**NY Power  
Authority**

Crescent Hydroelectric Project, FERC Project No. 4678-052  
Vischer Ferry Hydroelectric Project, FERC Project No. 4679-049  
Response to ISR Comments and Submission of Revised Study Plan

## **Attachment 2 – Prorated Flow Plots for Crescent and Vischer Ferry Projects**

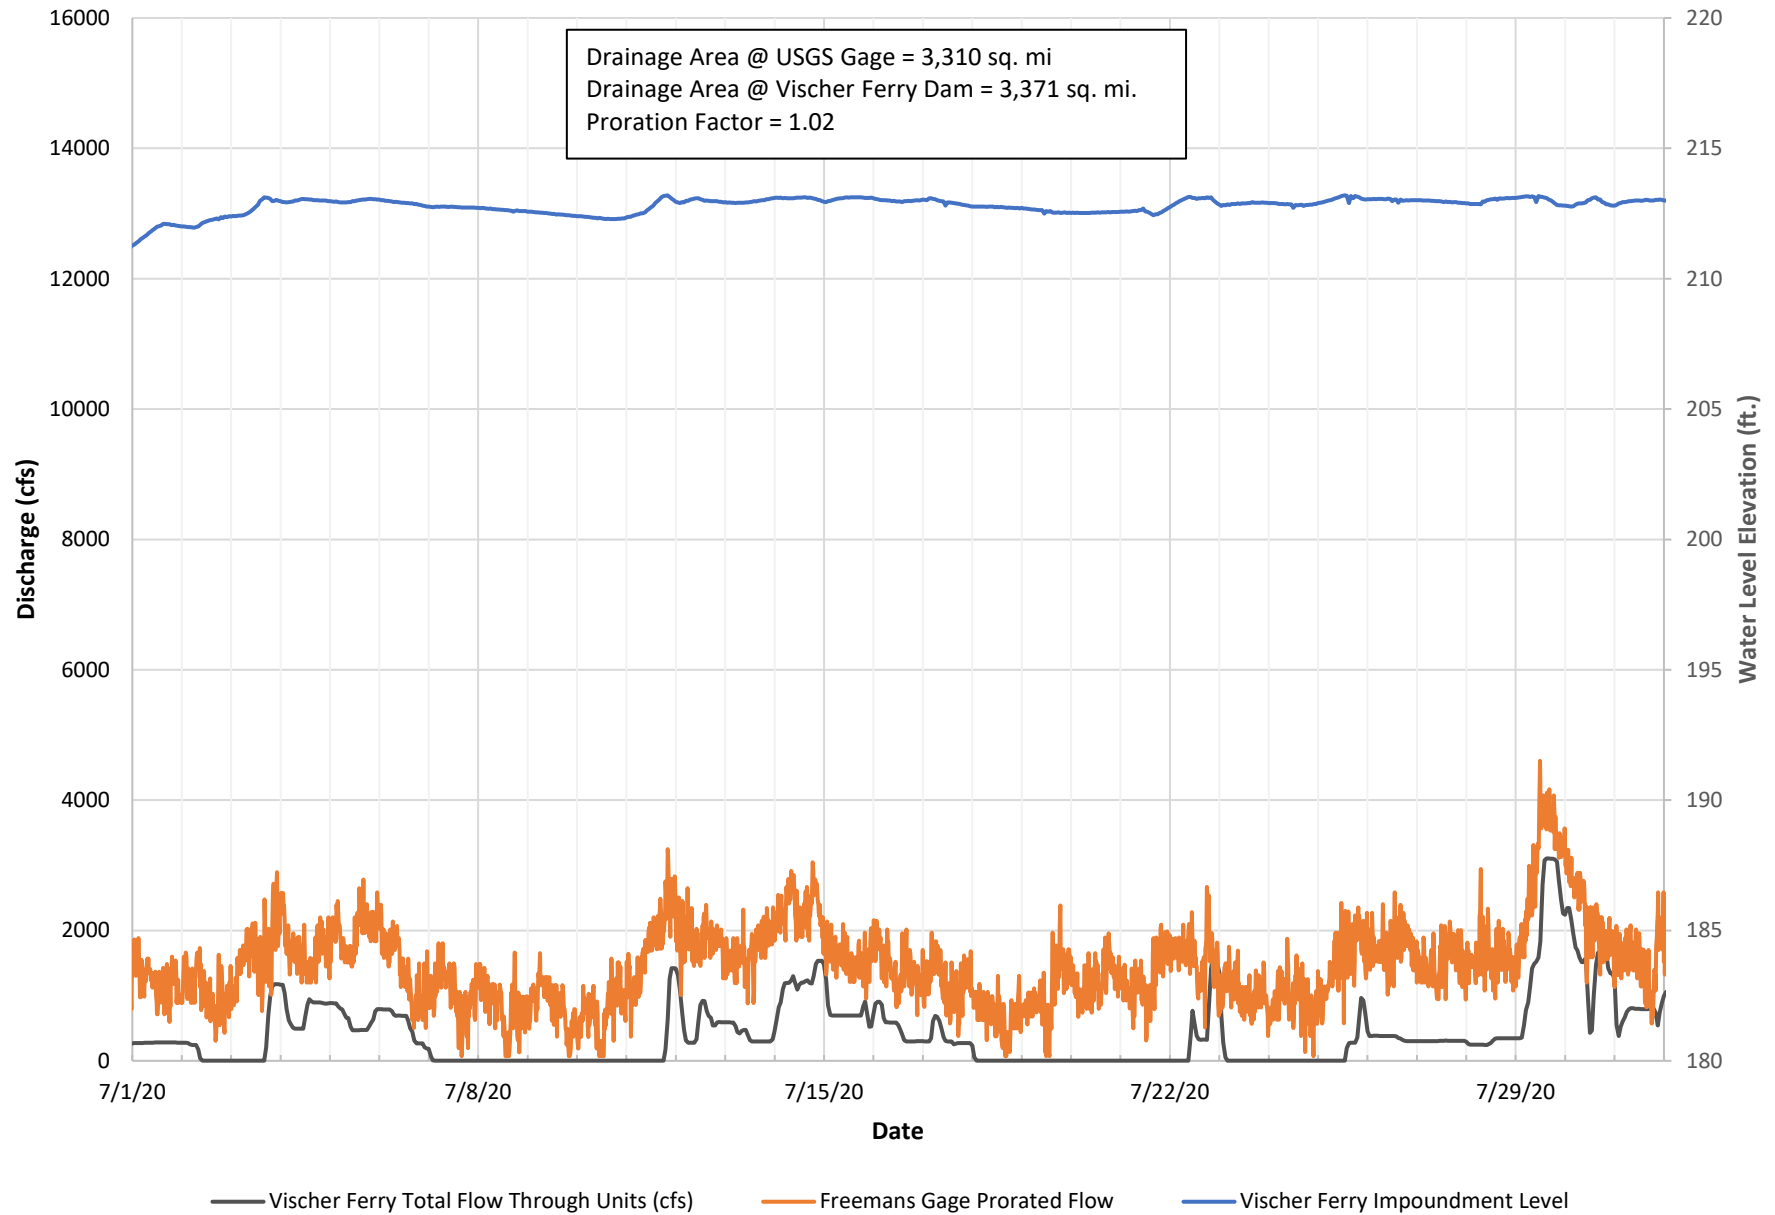
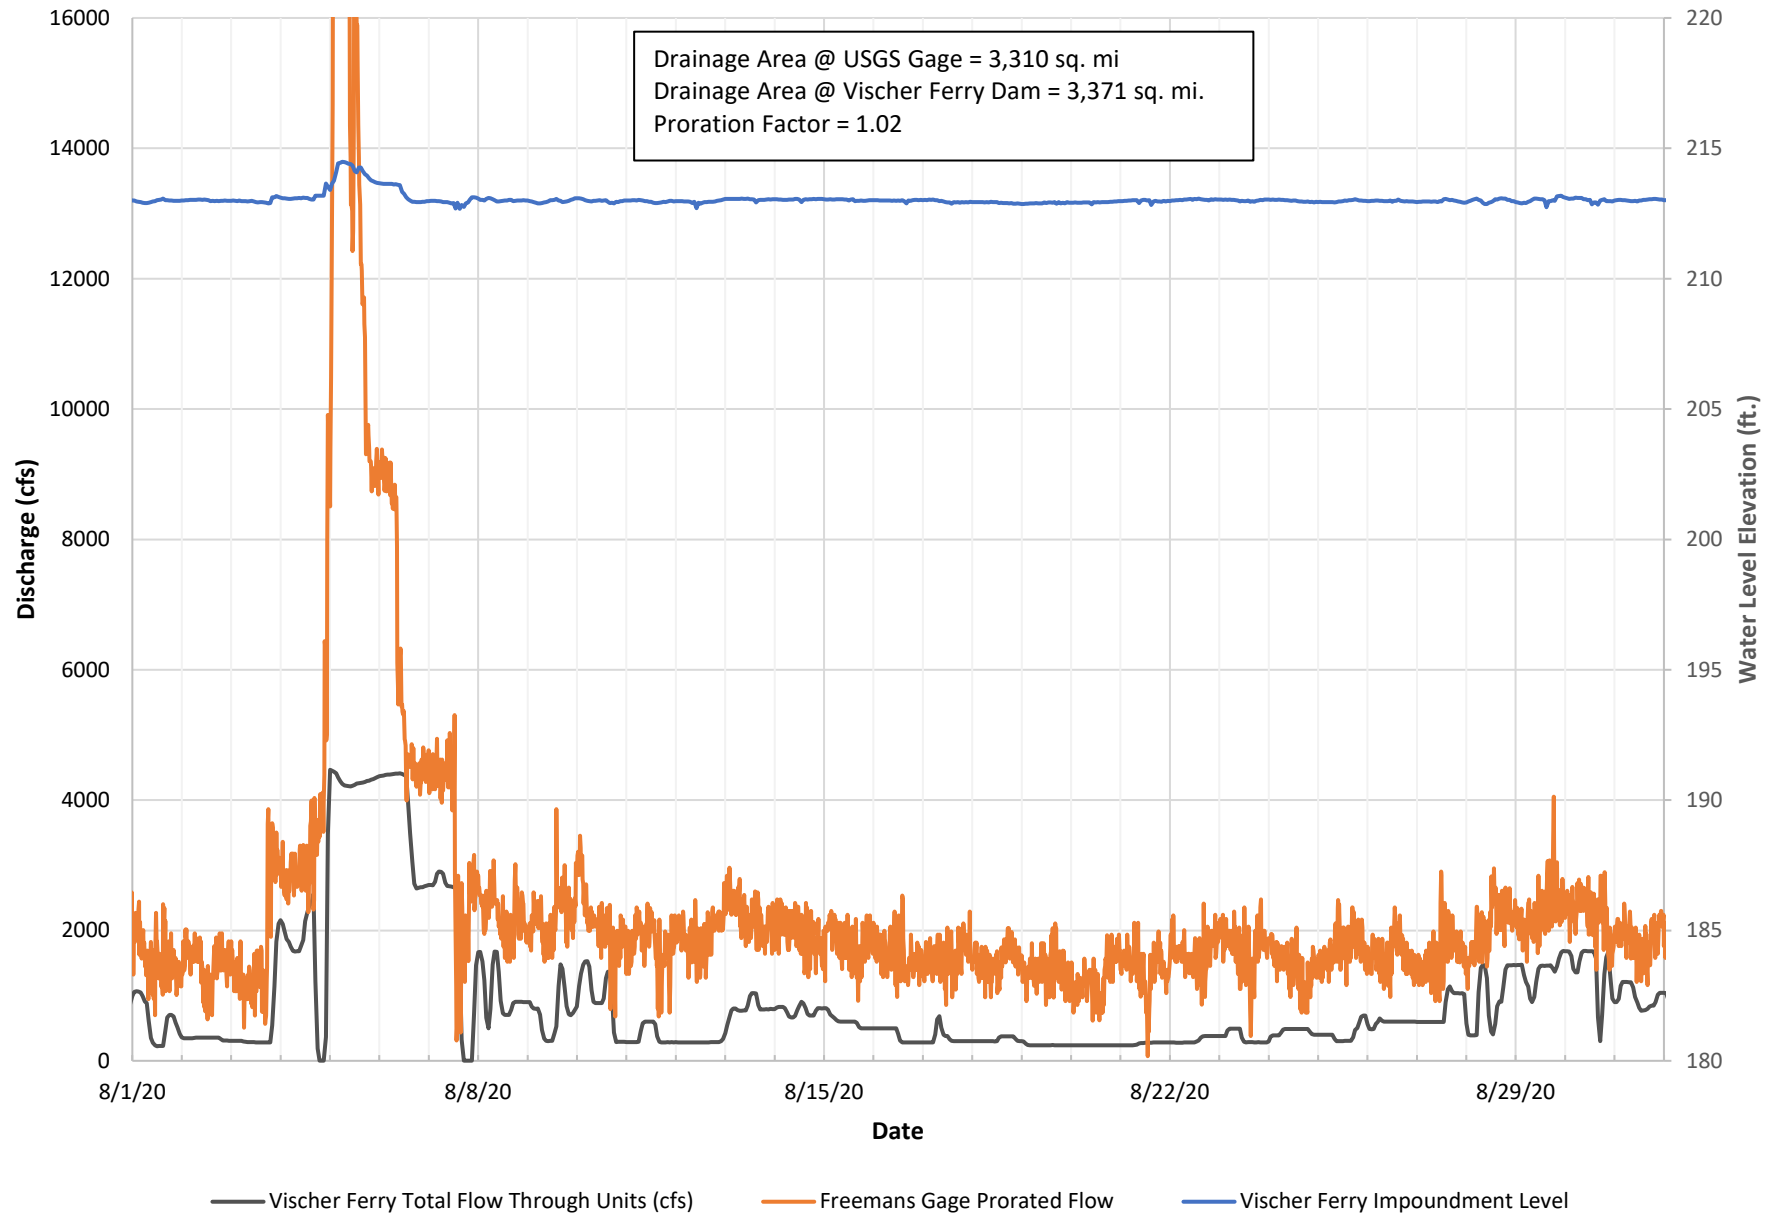
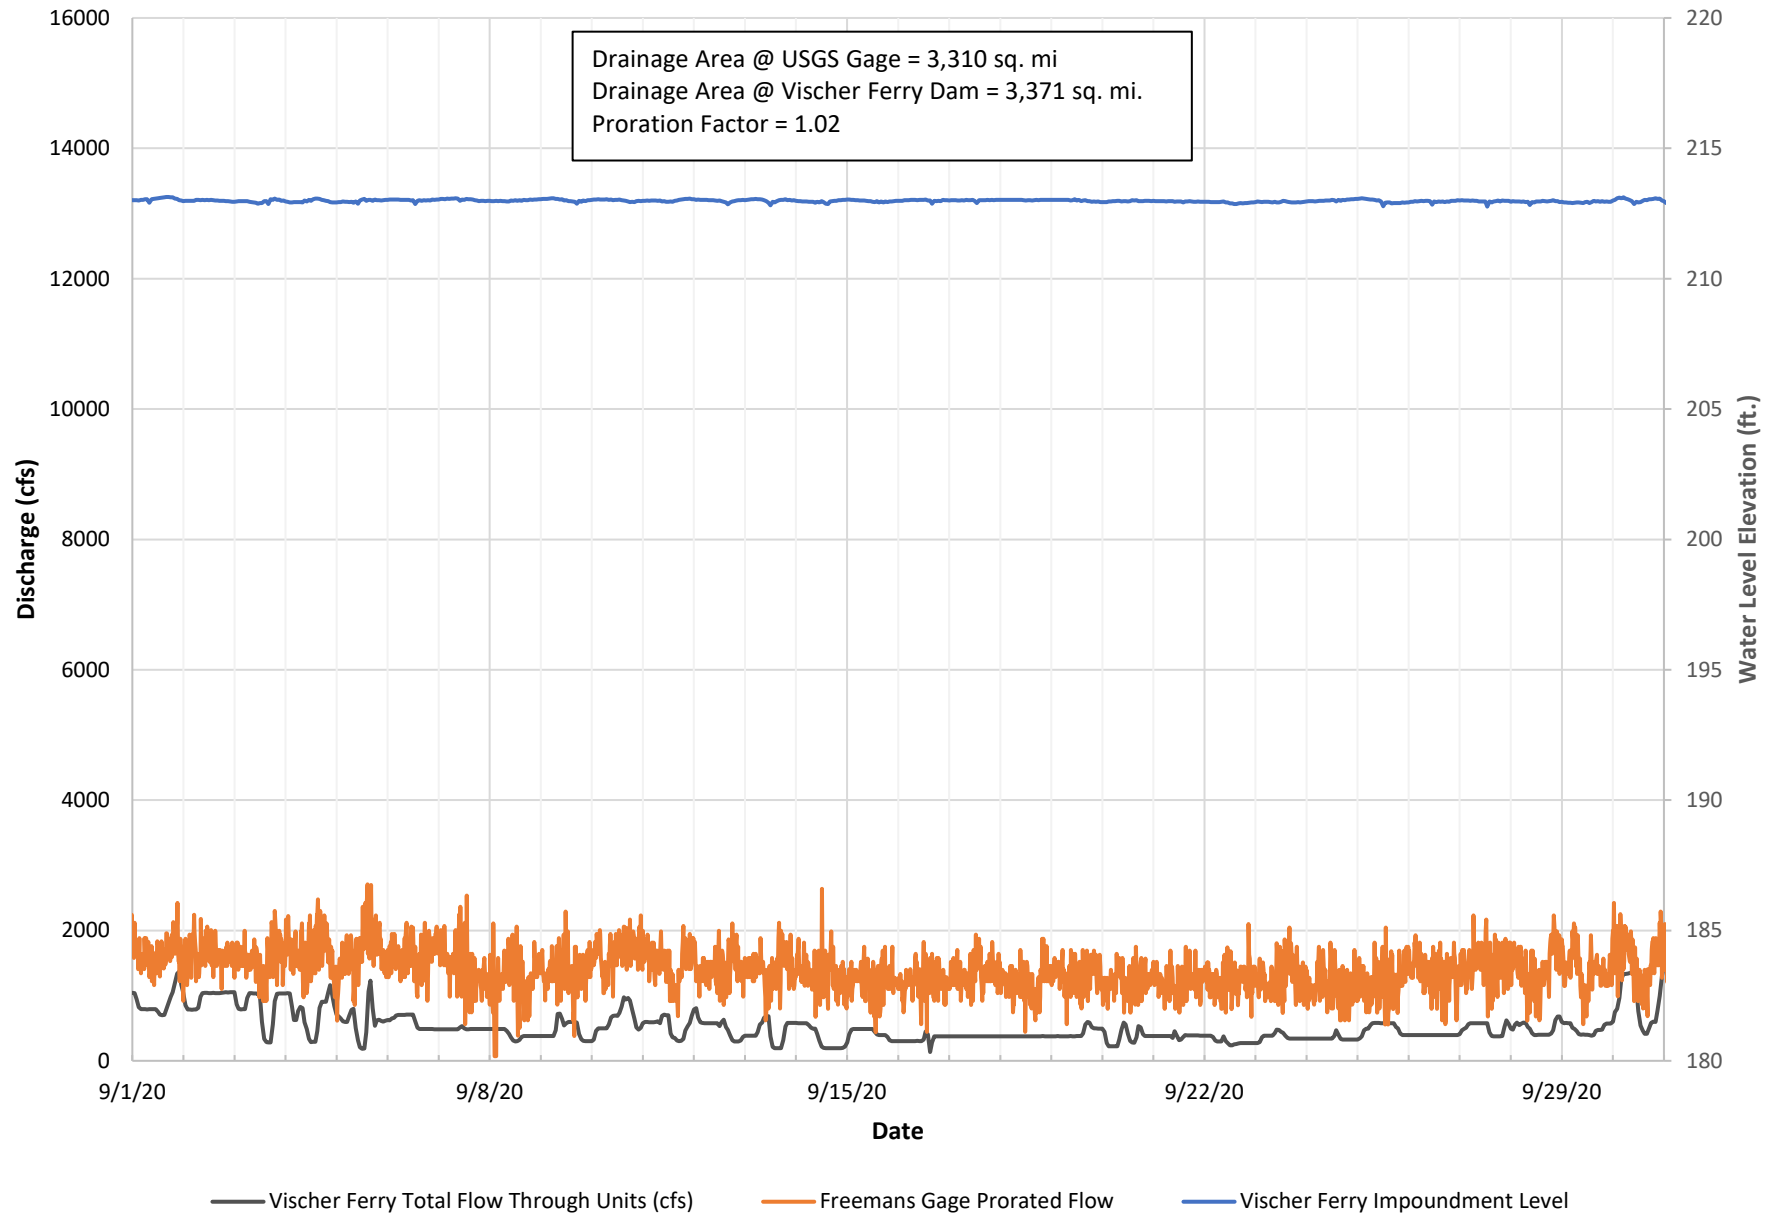
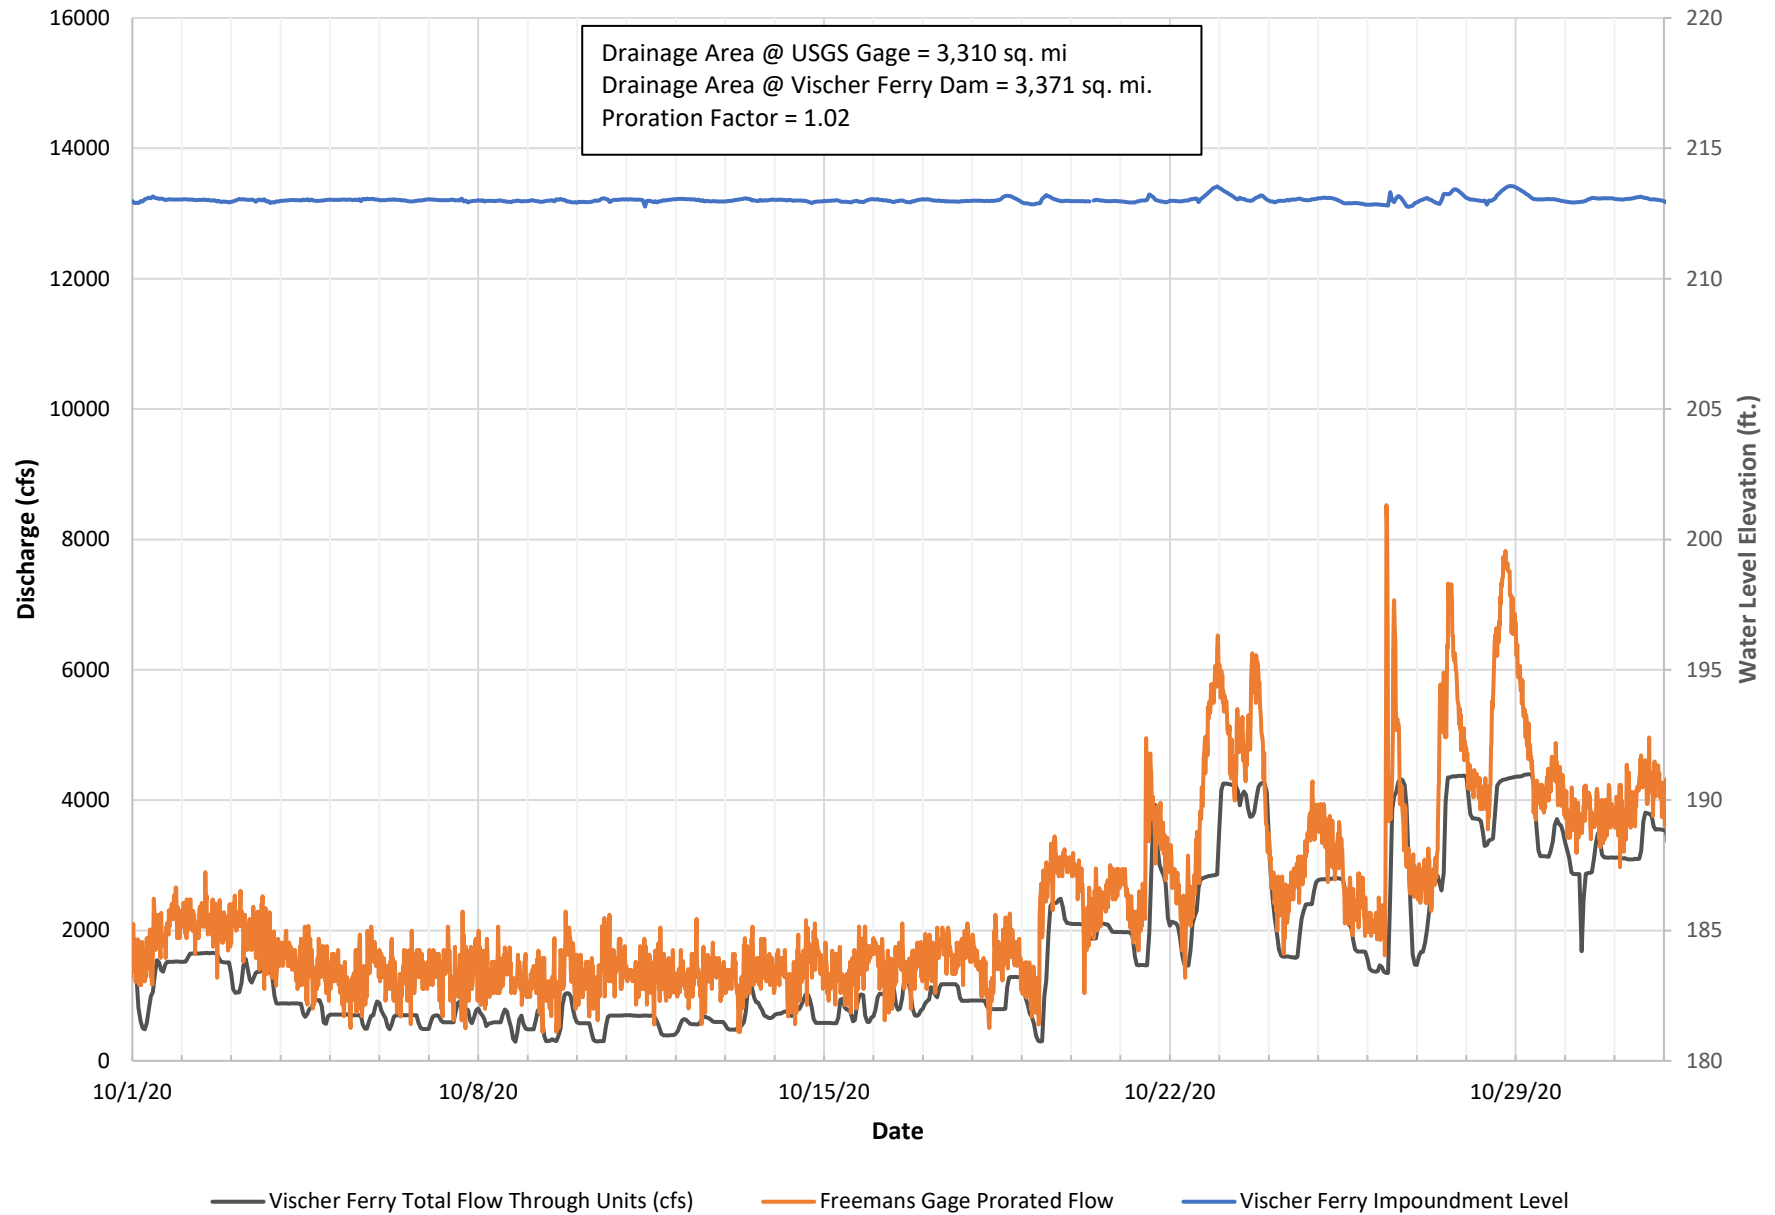
**Comment 2:** NYSDEC (4/16/2021) requests that the Power Authority graph the total prorated flow that passes the Projects with generation flow included. NYSDEC notes that this will provide a more complete understanding of flows at the Projects, how they are being utilized, and confirm that the minimum flows are also being provided.

**Response 2:** The Power Authority has developed the requested graphs of prorated flows (based on drainage area) at the Vischer Ferry and Crescent Projects, using the flow data from the upstream USGS gage (no. 01354500) on the Mohawk River at Freeman's Bridge (Attachment 2). The drainage area at the USGS gage is 3,310 sq. mi. and proration factors used were 1.02 for the Vischer Ferry Project and 1.05 for the Crescent Project. Also shown on the flow graphs is elevation data for the two Project impoundments. As shown, impoundment fluctuations were minimal throughout the study period, demonstrating that the Projects were operating as run-of-river throughout the study season.
